February 10, 1987

SUBJECT: COMANCHE PEAK STEAM ELECTRIC STATION (CPSES)
DOCKET NOS. 50-445 AND 50-446
REQUEST FOR INFORMATION REGARDING INSPECTION REPORTS:
50-445/85-07, 50-446/85-05; 50-445/85-14, 50-446/85-11;
50-445/85-16, 50-446/85-13; 50-445/86-06, 50-446/86-04

SUPPLEMENTAL REQUEST FOR INFORMATION REGARDING
INSPECTION REPORTS
50-445/85-07, 50-446/85-05; 50-445/85-14, 50-446/85-11;
50-445/85-16, 50-446/85-13; 50-445/86-06, 50-446/86-04

CP-244

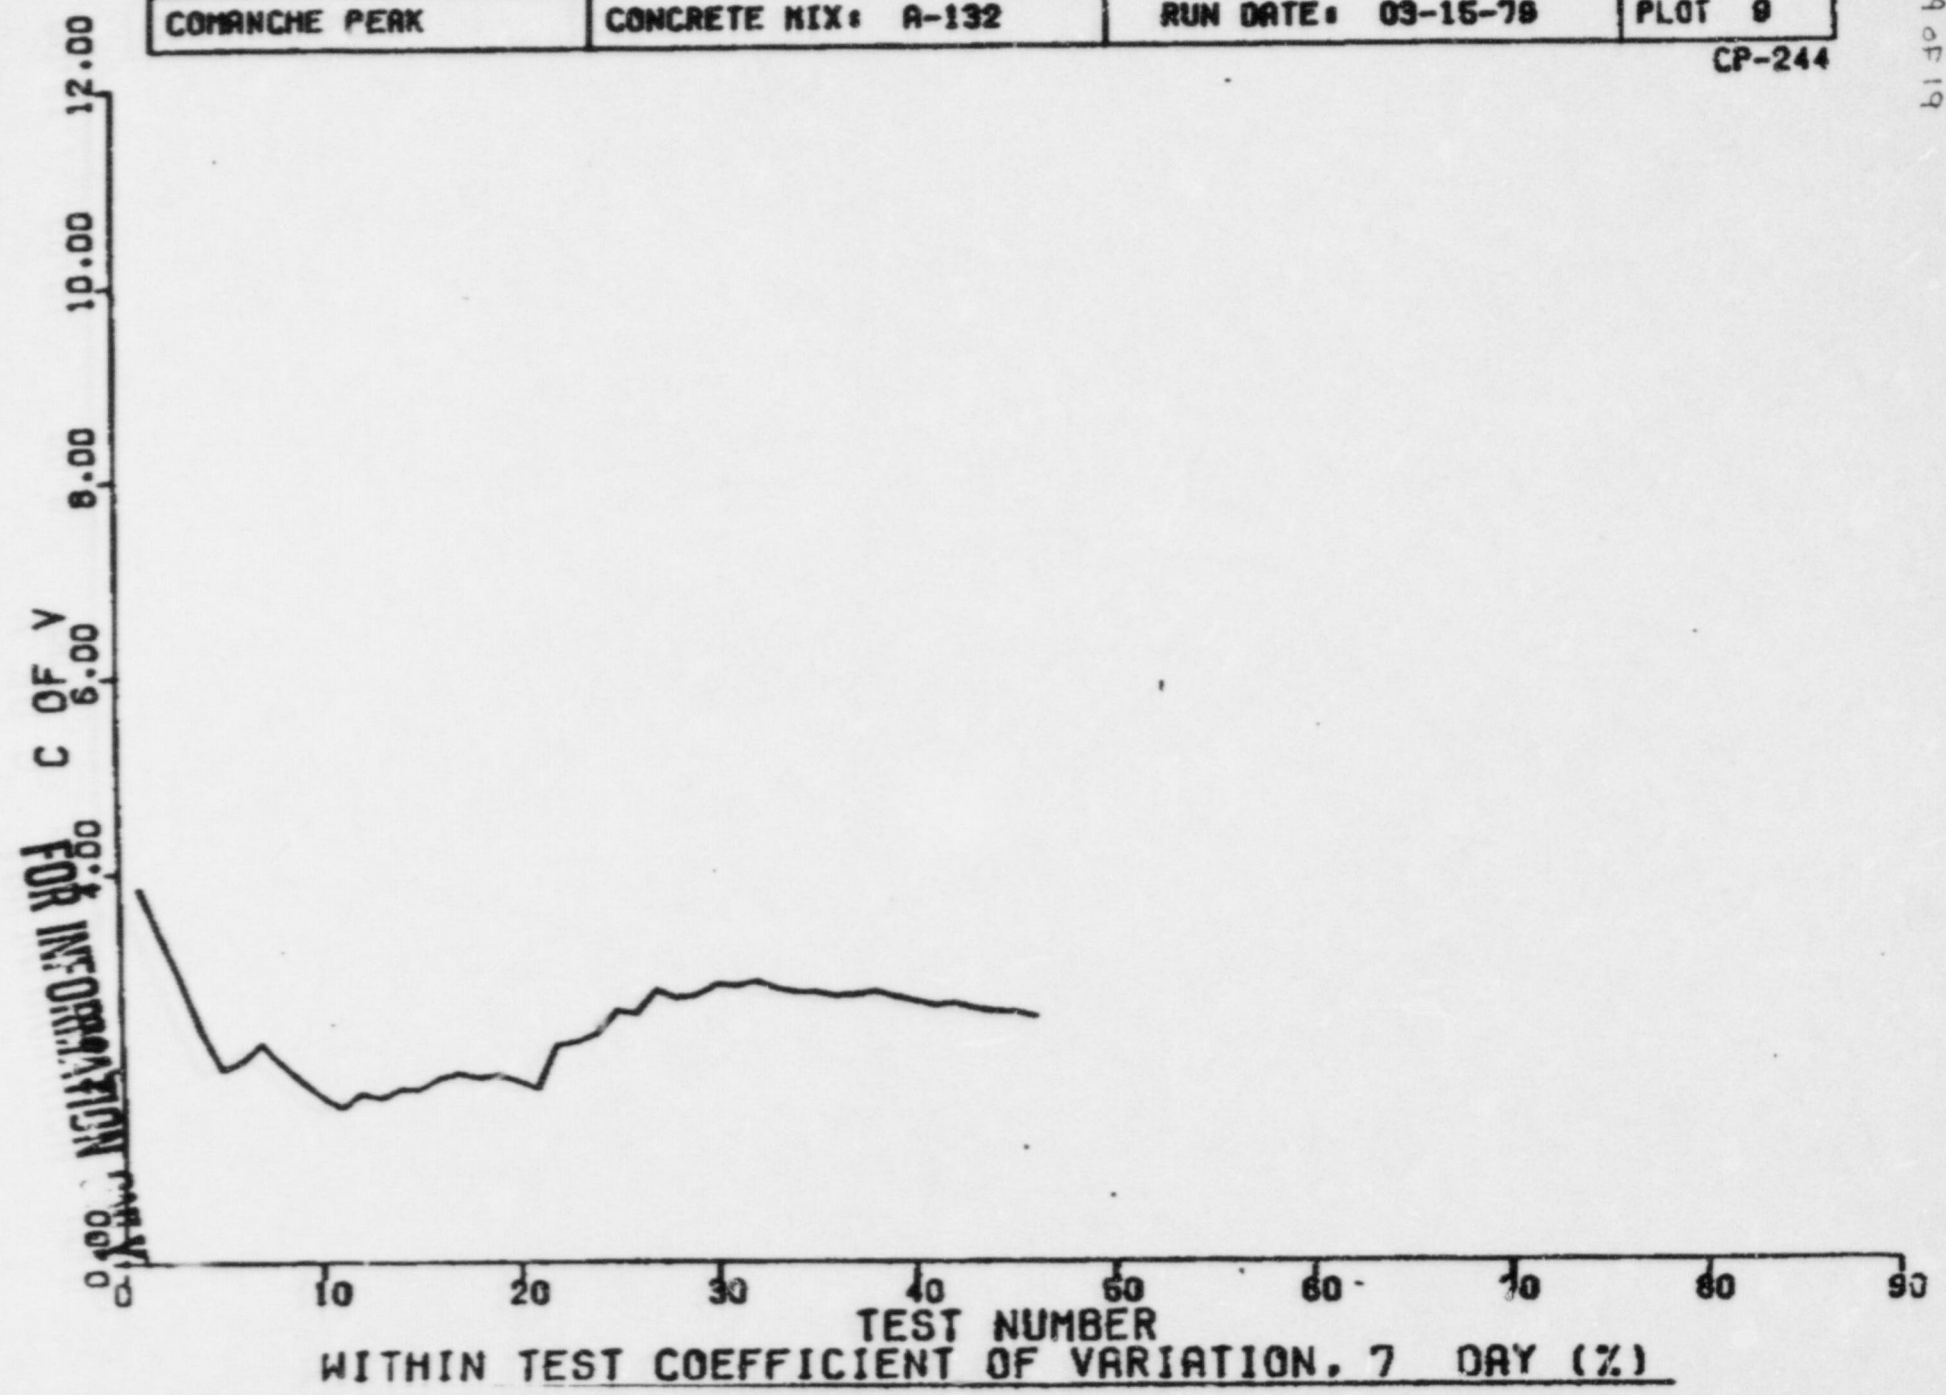
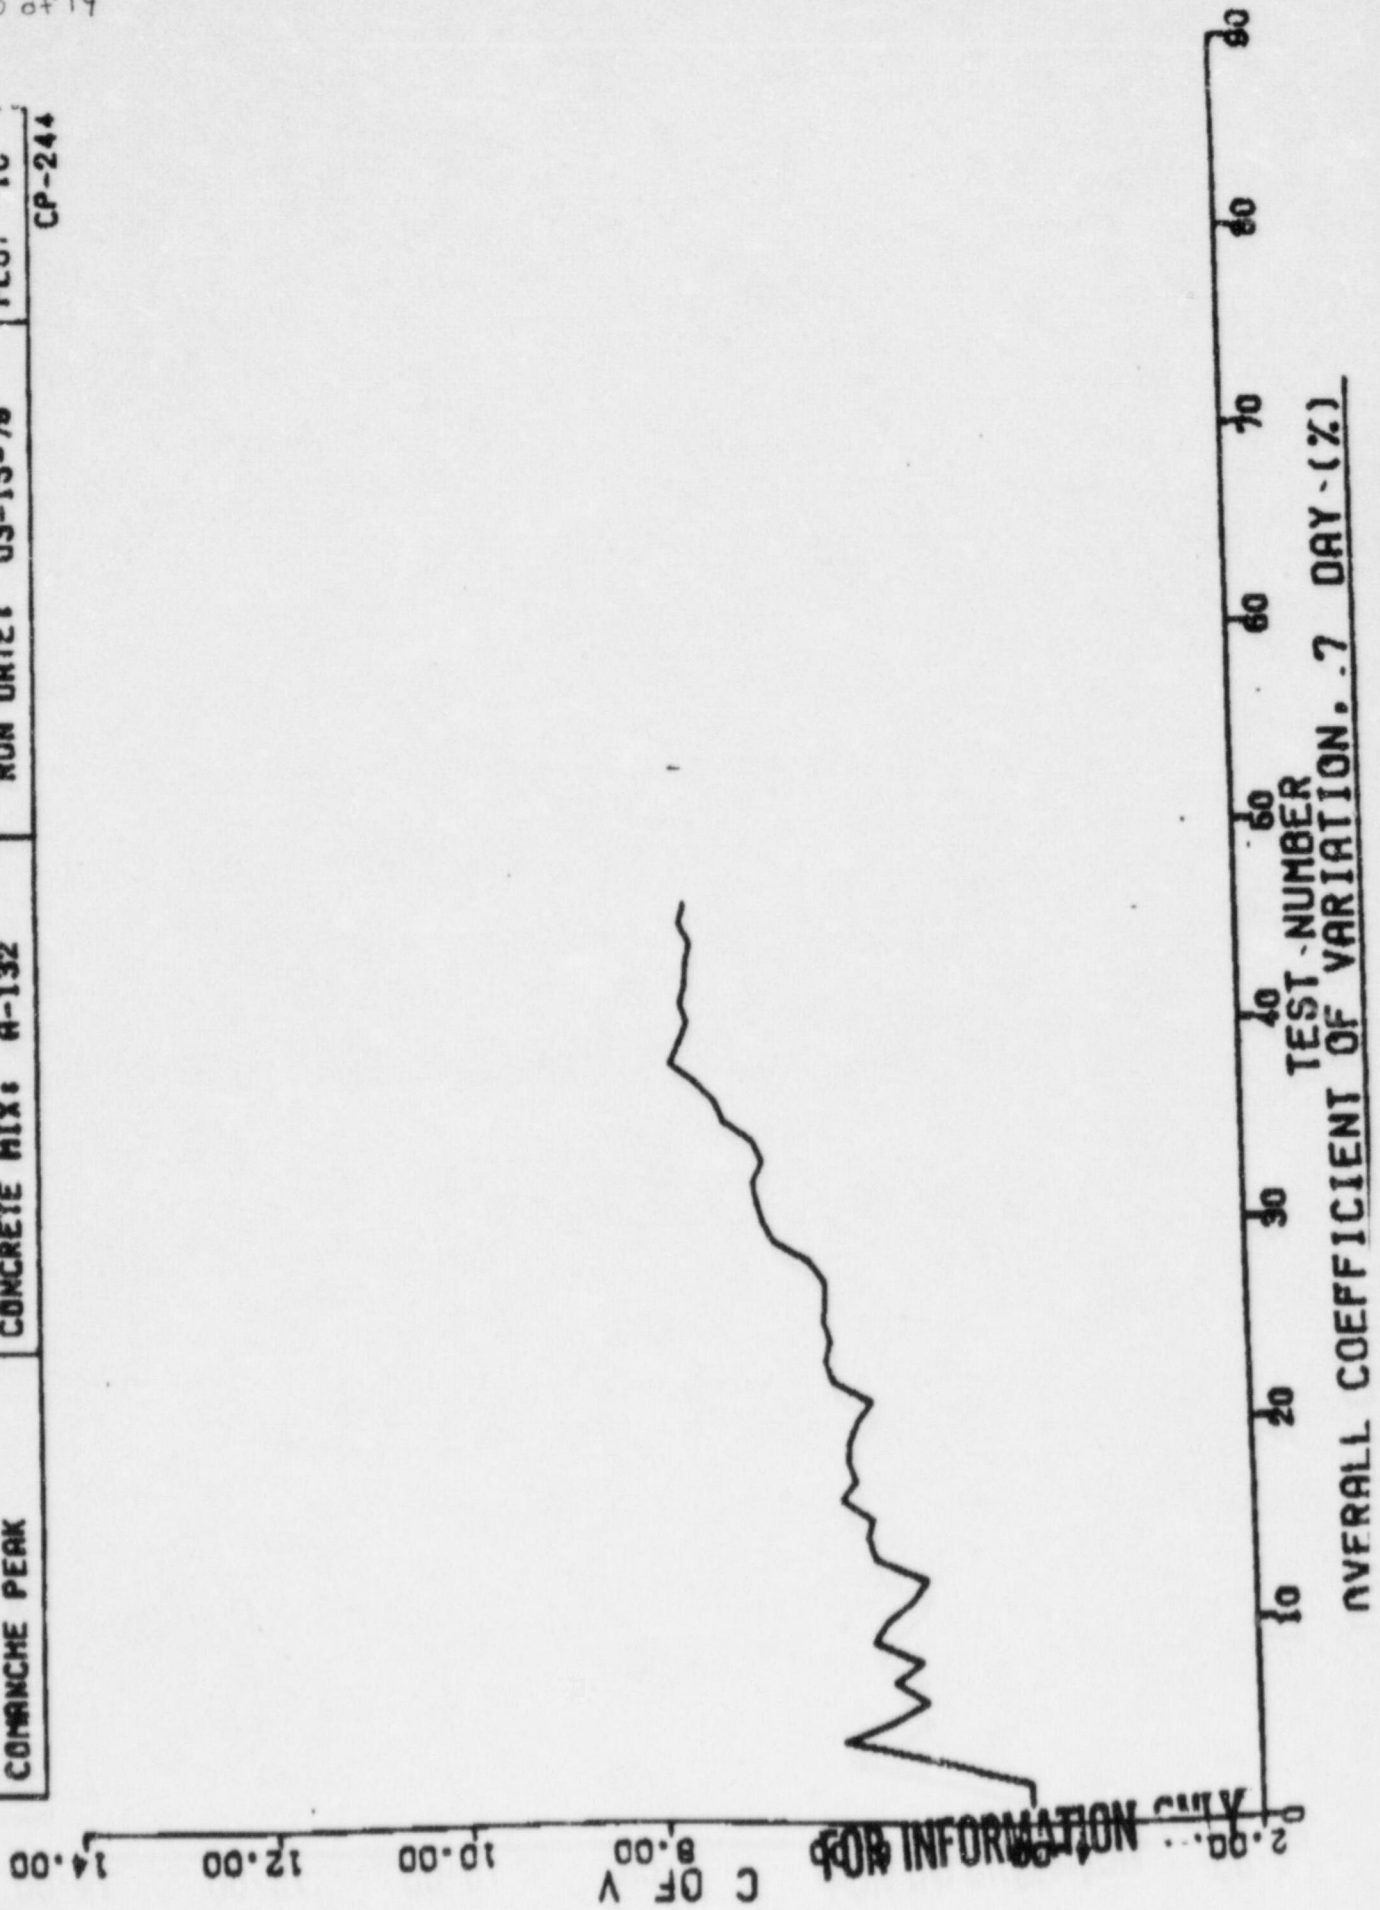
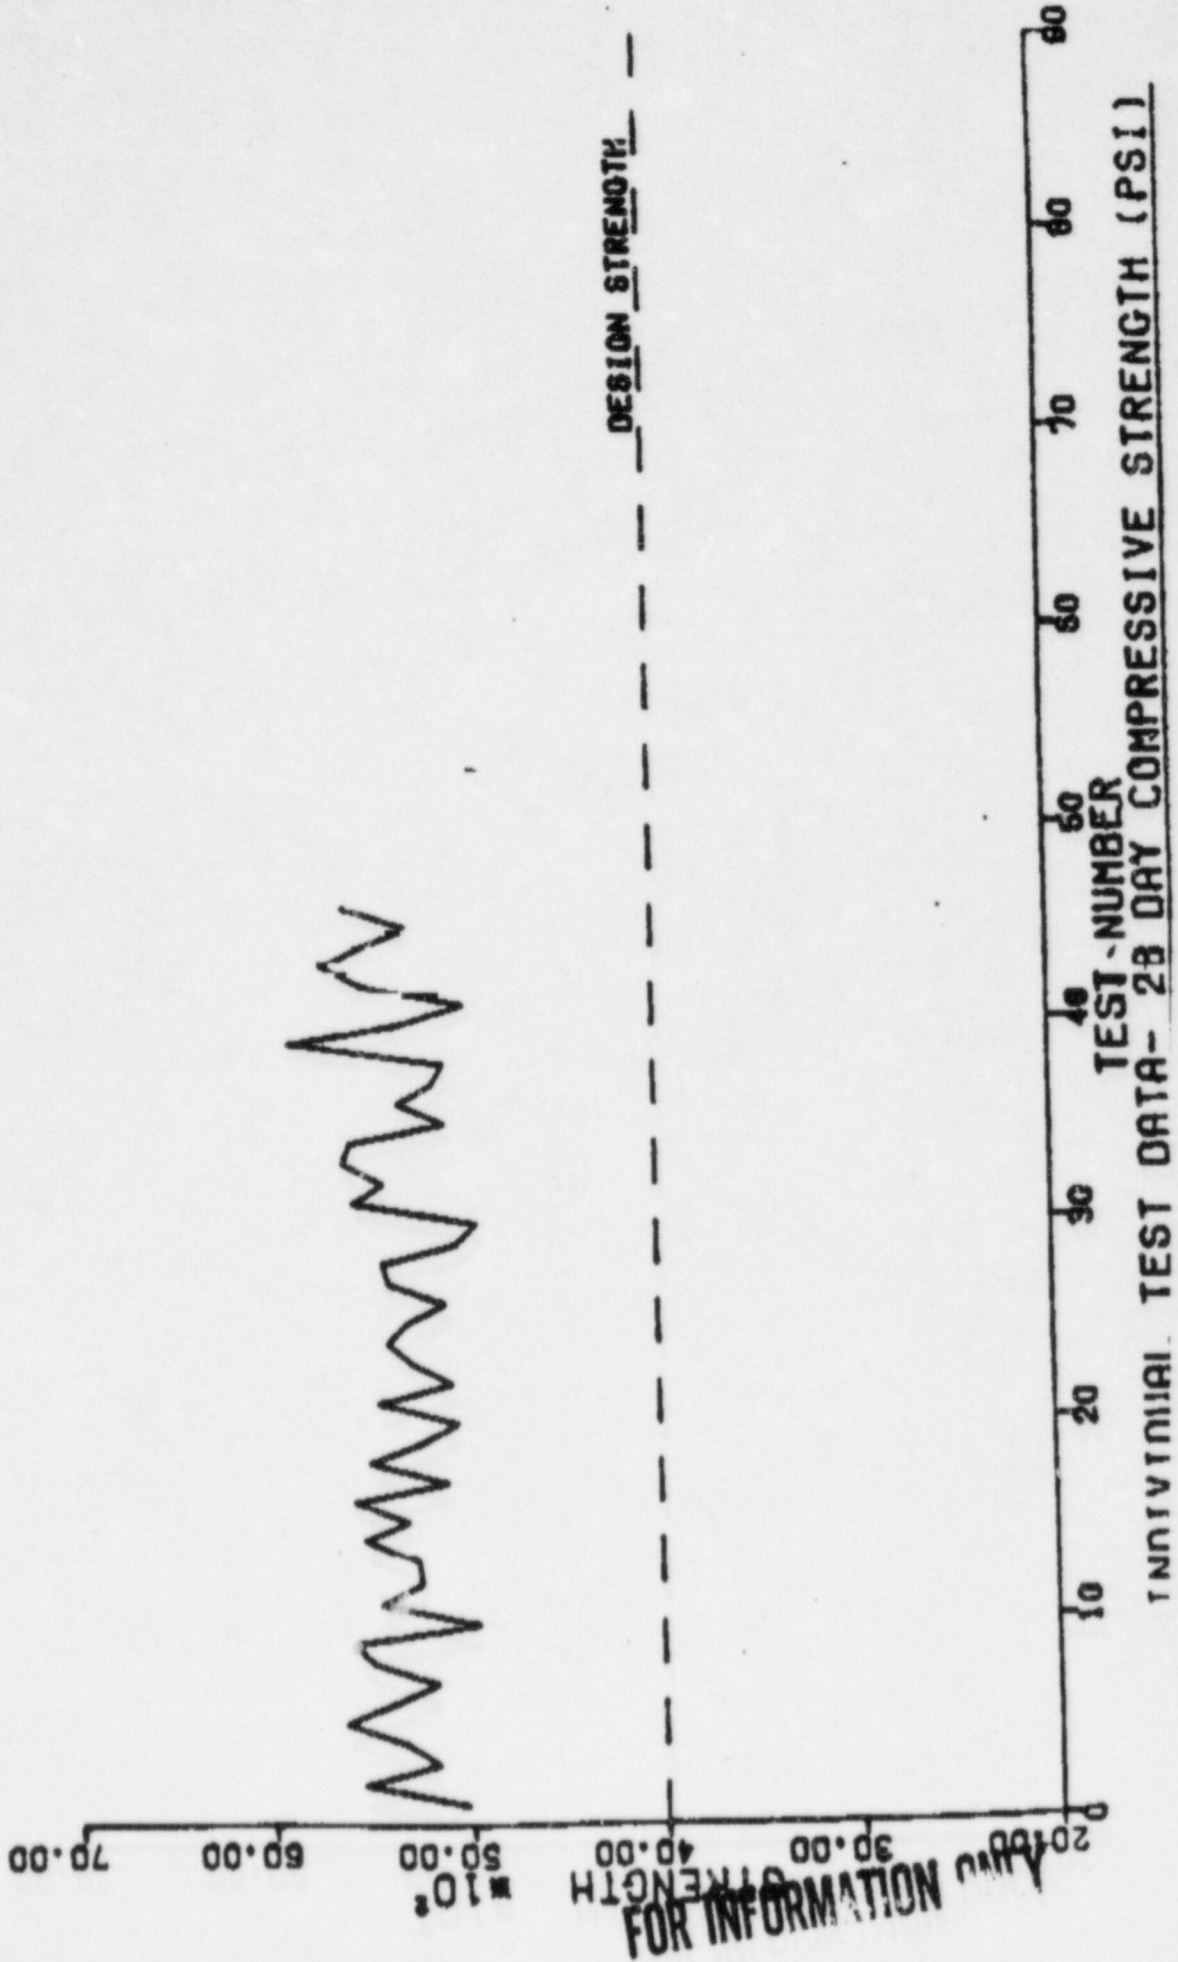
4. With reference to inspection report 50-445/85-07, 500-446/85-05, and NOV 445/8507-04, 446/8505-02, although no records exist that concrete mixing blades had been inspected quarterly since trucks were placed in service in 1977, it is our understanding that there are consistent concrete strength and uniformity tests.
 - a. Does TU Electric have a concrete strength statistical distribution for this period?
 - b. Provide three (3) results reports spaced over this period (i.e., 1977, 1980 and 1984).

Enclosure 1 is a statistical evaluation of a series of concrete tests run during 1978. This is one of several statistical evaluations run during the 1973 to 1979 time frame.
